**NFPA Building Code/Safety to Life Technical Committee on Means of Egress
(BLD/SAF-MEA)
NFPA 101/5000 Second Draft Meeting (A2026)**

**Public Comment No. 129-NFPA 101-2025 [Global Input]**

Figure 7.3.1.2(a) Mall Structure Occupant Load Factors (US Customary Units).

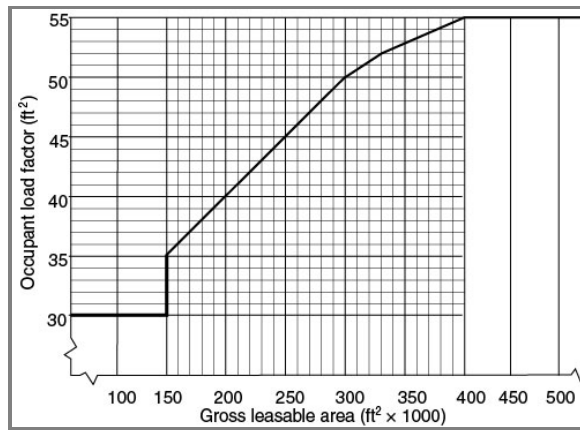
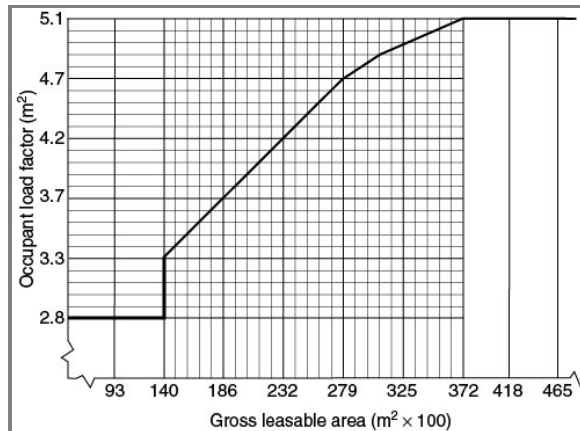
Public Comment No. 30-NFPA 101-2025 [Section No. 7.3.1.2]

The occupant load in any building or portion thereof shall be not less than the number of persons determined by dividing the floor area assigned to that use by the occupant load factor for that use as specified in Table 7.3.1.2, Figure 7.3.1.2(a), and Figure 7.3.1.2(b). Where both gross and net area figures are given for the same occupancy, calculations shall be made by applying the gross area figure to the gross area of the portion of the building devoted to the use for which the gross area figure is specified and by applying the net area figure to the net area of the portion of the building devoted to the use for which the net area figure is specified.

I attempted to fix this through a code change with Target in a previous cycle, but was told the request was too vague so I've modified it to apply only to what would be Big Box retail with the smaller retail shops still needing the 30 square feet per person load factor. When I presented this change to the committee, the committee argued that this would also impact shopping malls in other parts of the world. I don't know how to fix that problem as one could also argue that the IBC and IFC could be adopted internationally and now we have a worldwide conflict in terms of occupant load calculations.

When COVID 19 hit, more people turned to online shopping as a result and many of them continue to shop in this fashion today. More and more retailers are experiencing peak numbers in online pick ups from their customers. This method of shopping has contributed to a decline in the number of people in brick and mortar buildings. Looking at the numbers and accounting for the decrease in the number of people physically shopping, the occupant load factor of 60 should be a reasonable change.

Figure A.7.2.1.2.2(a) Door Width — Egress Capacity.**Figure A.7.2.1.2.2(b) Door Width — Egress Capacity with Permitted Obstructions. Width Measurement with Boundary/Edge Effect Clearances. <<Replace Figure A.7.2.1.2.2(b) with one of the attached figures.**

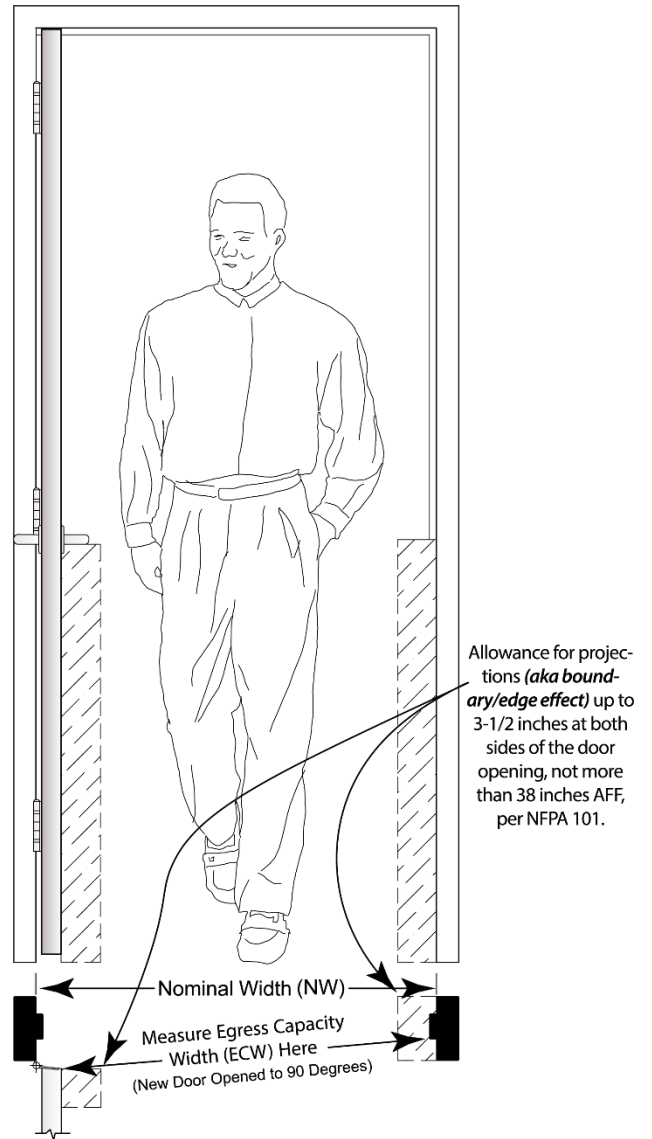
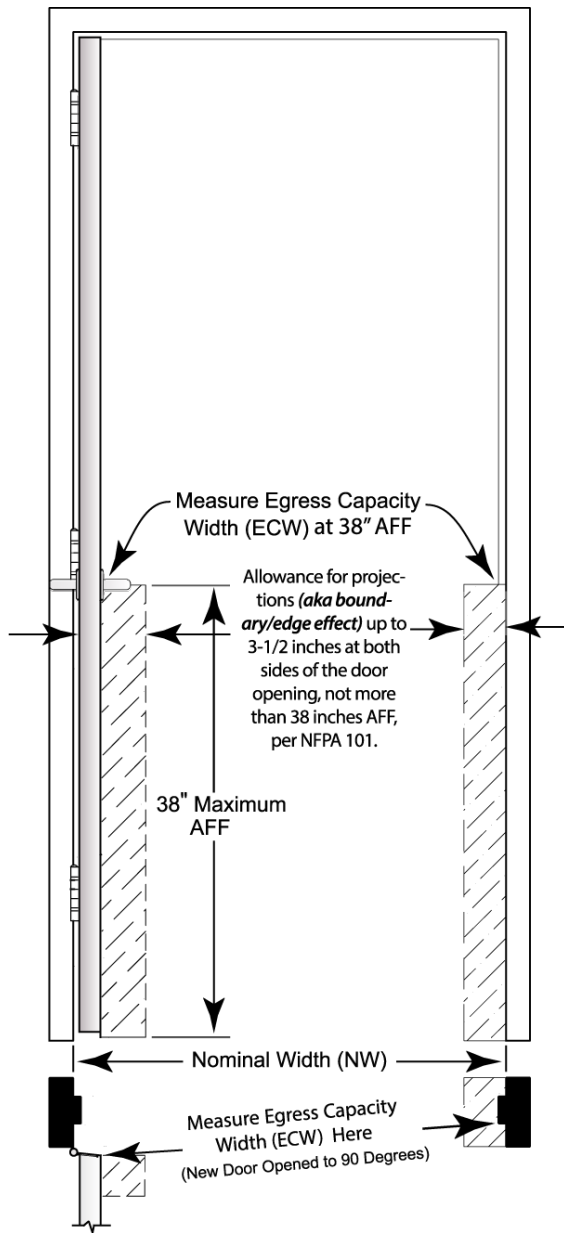
**Public Comment No. 34-NFPA 101-2025 [Section No. A.7.2.1.2.2]****A.7.2.1.2.2**

means of egress (other than door openings) for purposes of calculating egress capacity. The egress capacity of door openings is regulated by 7.2.1.2.2.1, which substitutes a maximum 3½ in. (90 mm) projection at each side of the door opening in place of the 4½ in. (114 mm) projections permitted by 7.3.2.2. Figure A.7.2.1.2.2(b) depicts the allowable encroachment at each side of a door opening.

"The egress capacity of door openings is regulated by 7.2.1.2.2.1, which substitutes a maximum 3½ in. (90 mm) projection at each side of the door opening in place of the 4½ in. (114 mm) projections permitted by 7.3.2.2. Figure A.7.2.1.2.2(b) depicts the allowable encroachment at each side of a door opening."

This statement clearly applies the boundary/edge effect concept to doorways regarding where the egress capacity width measurements need to be taken (e.g., at 38 inches above the floor) for the purposes of calculating egress capacity only. The 3-1/2-inch encroachments at both sides of the door opening in the door frame are theoretical to account for the shape of human bodies rather than for physical items. Additionally, 7.2.1.2.1.1(5) prohibits projections into the clear width opening dimension below 34 inches above the floor. In other words, 7.2.1.2.1.1 does not allow for the encroachments referenced in 7.2.1.2.2.1(5).
